**CYPRUS PLATEAU
MINING CORPORATION**
A Cyprus Amax Company

March 20, 1996

**RE: RESPONSE TO UTAH DIVISION OF WILDLIFE RESOURCES COMMENTS ON
WILLOW CREEK PERMIT APPLICATION**

EXHIBIT A

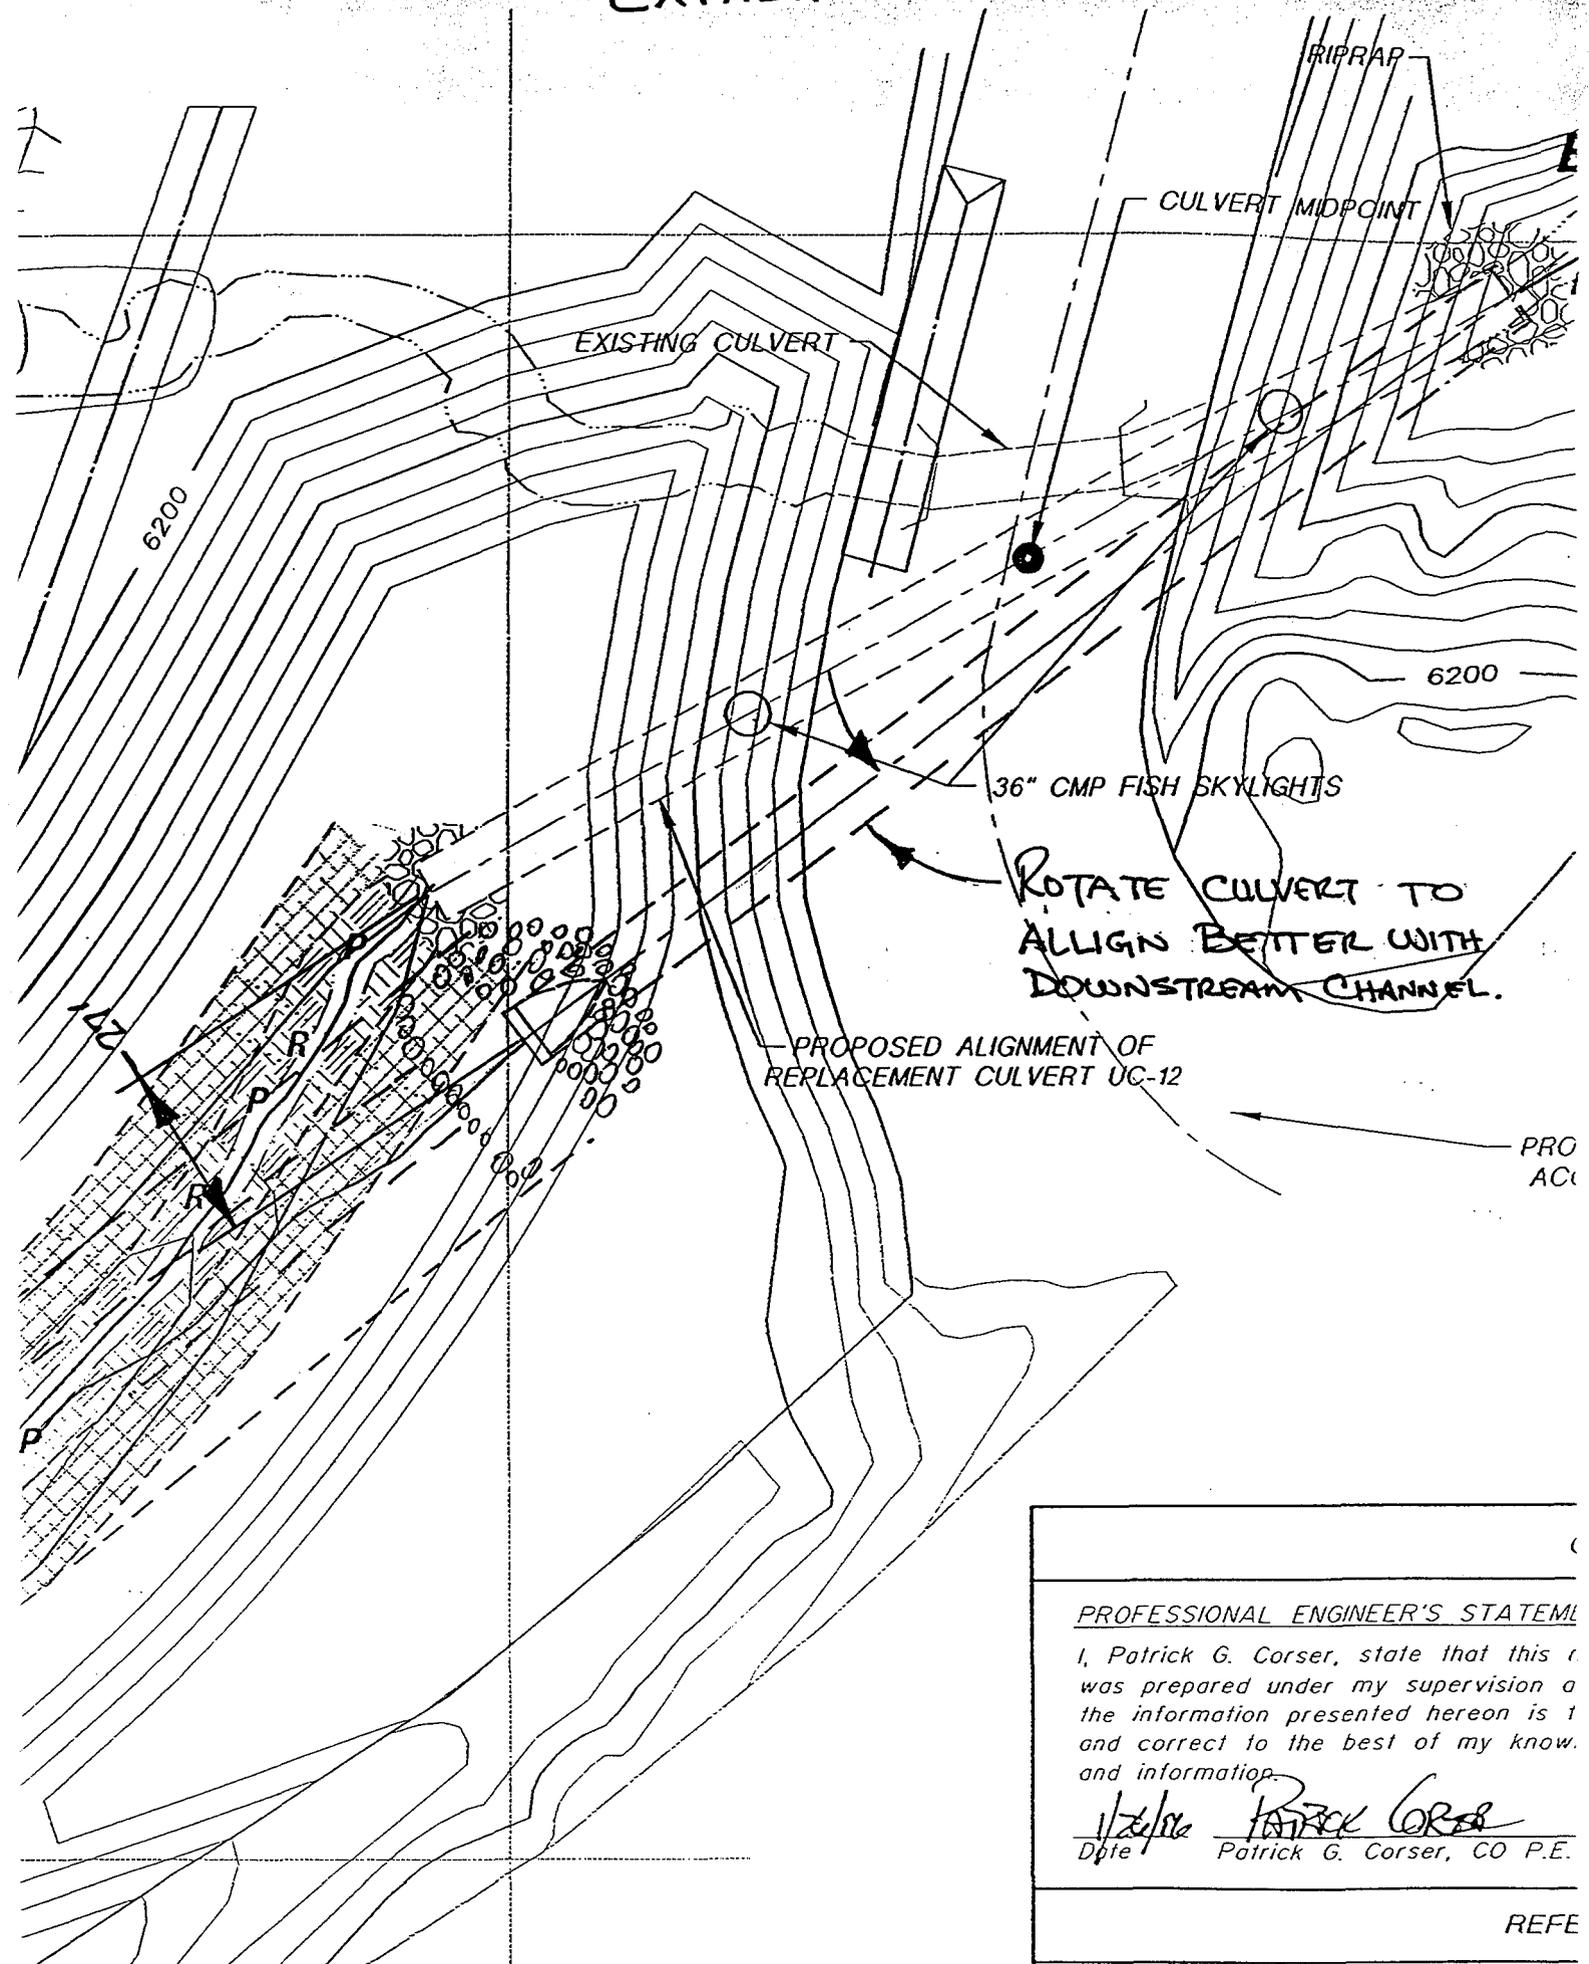
- Item 1a. The relocated stream sections are acceptable as designed with exception of the channel immediately below the 96" culvert. This section of channel will be redesigned to provide a straight section immediately below the culvert to prevent adverse affects to the channel bank. The west end of the culvert will be moved to the south to provide a better alignment of the channel (see Exhibit A).

EXHIBIT B
WILLOW CREEK CULVERT CROSS SECTION
SCALE 1" = 3'

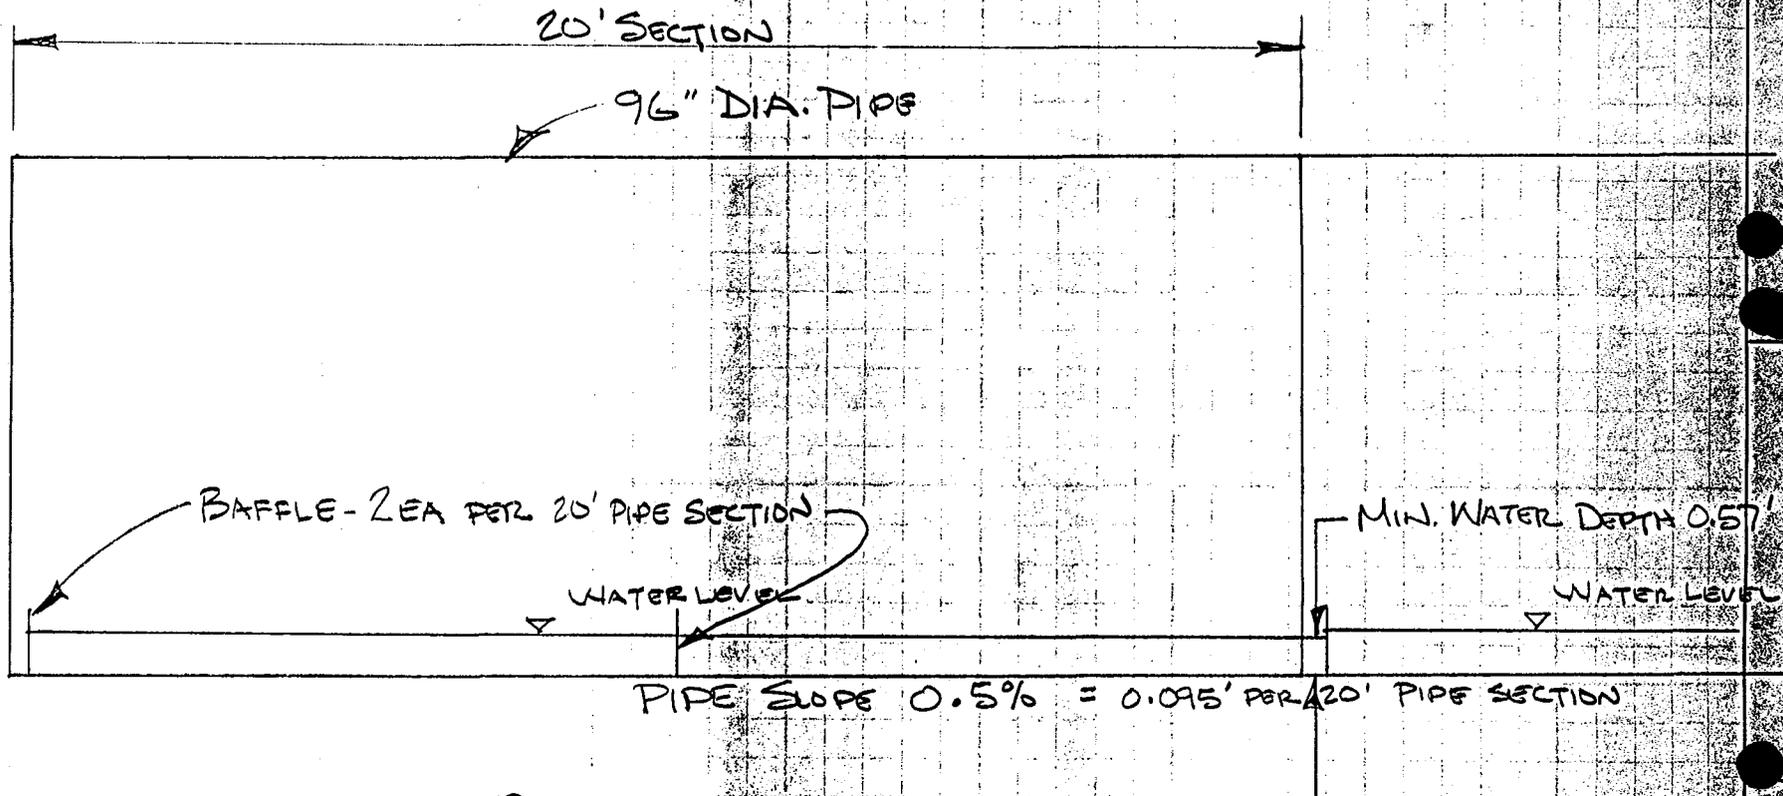
C. No fill material will be placed inside the culvert.

The culvert slope was originally designed to limit the flow velocity during normal flow conditions to no more than 3.5 feet per second to allow fish to migrate through the culvert. With the addition of baffles, the flow velocity will be less than 3.5 feet per second due to the partial blockage or pooling effect created by the baffles.

WILLOW CREEK CULVERT BAFFLE DETAIL

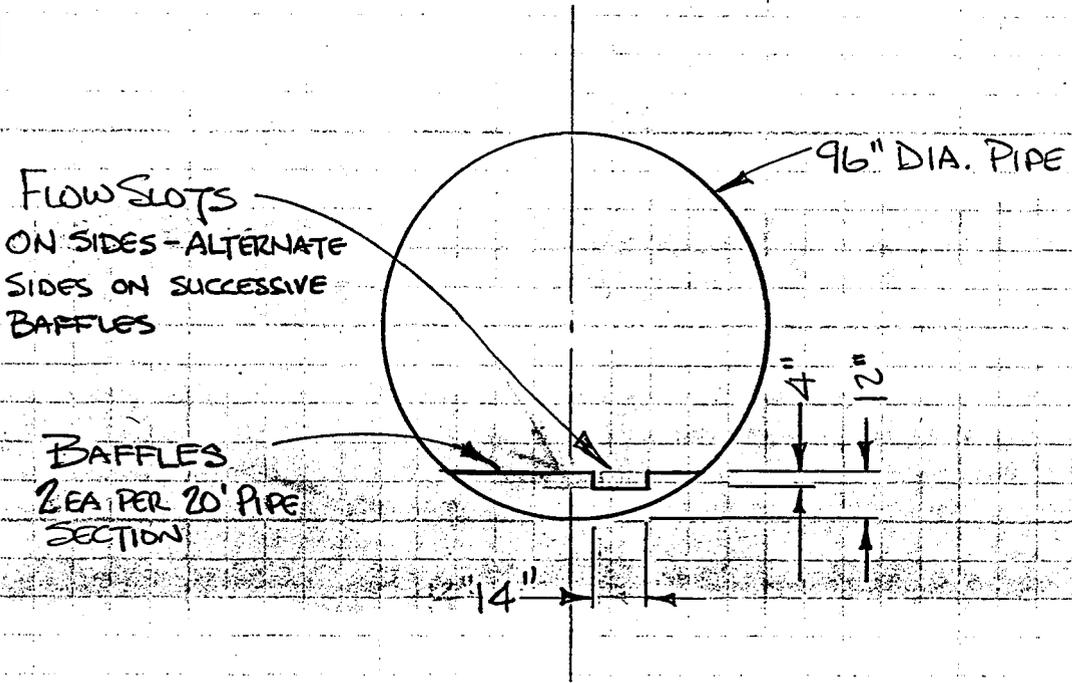
- Item 5. A round culvert is acceptable with the following installation requirements:
- A. Baffles as shown on Exhibit A will be constructed inside the culvert. The baffles will provide a constant water depth inside the culvert to allow fish to migrate through the culvert. The baffles will be placed on a 10 foot spacing and the slots will be constructed on the side and will be alternated from one side to the other on successive baffles;
 - B. A pool will be provided at the downstream end of the culvert at

FLOW SLOTS
ON SIDES - ALTERNATE
SIDES ON SUCCESSIVE
BAFFLES

BAFFLES
2 EA PER 20' PIPE
SECTION

WILLOW CREEK CULVERT OUTLET END DETAIL

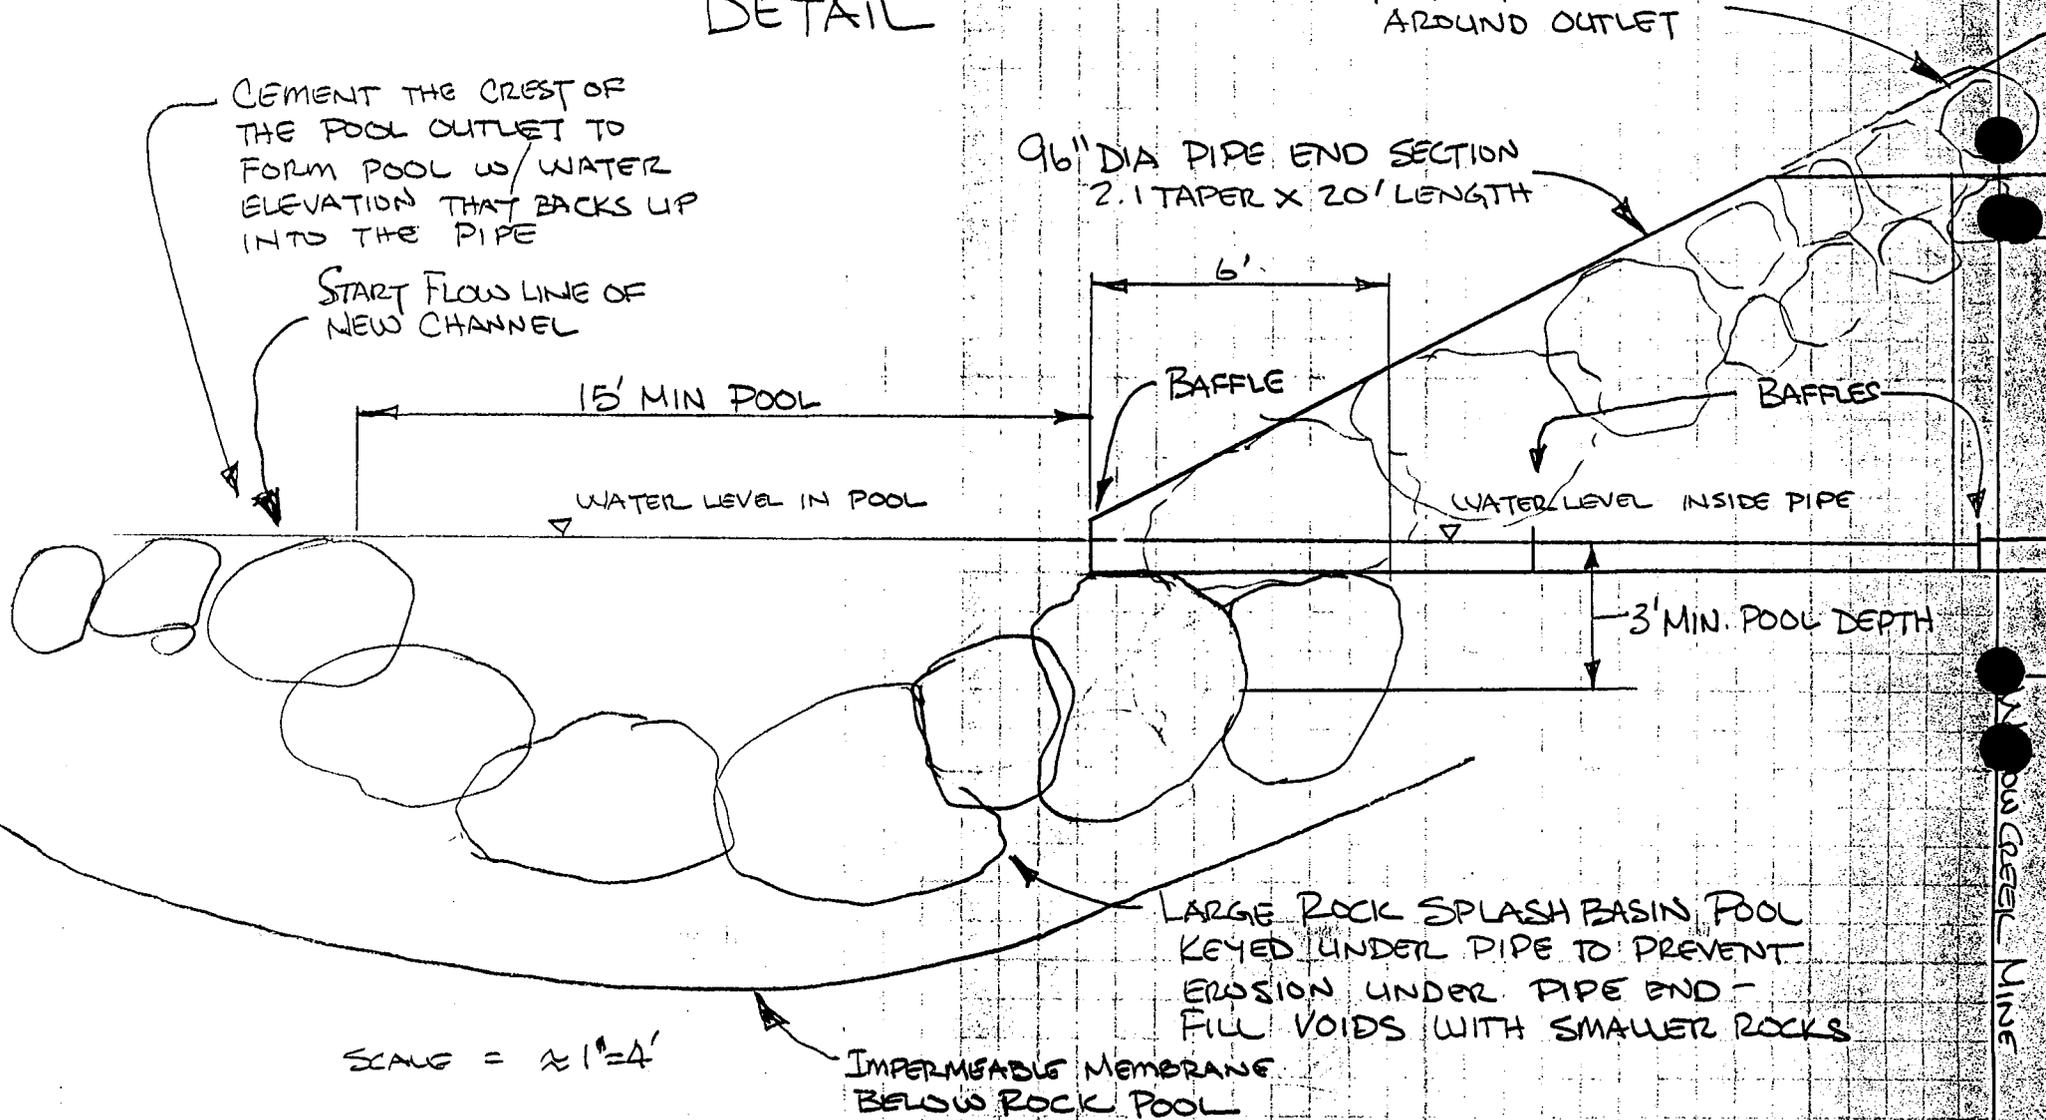
least 2 feet deep to allow fish to jump into the end of the culvert. The riprap at the lower end of the pool will be cemented to form a crest that will force the water to rise to the level of the end baffle crest in the pipe. This will provide a constant pool of water that extends back into the culvert. The concrete will be placed to be as inconspicuous as possible.

CEMENT THE CREST OF
 THE POOL OUTLET TO
 FORM POOL w/ WATER
 ELEVATION THAT BACKS UP
 INTO THE PIPE
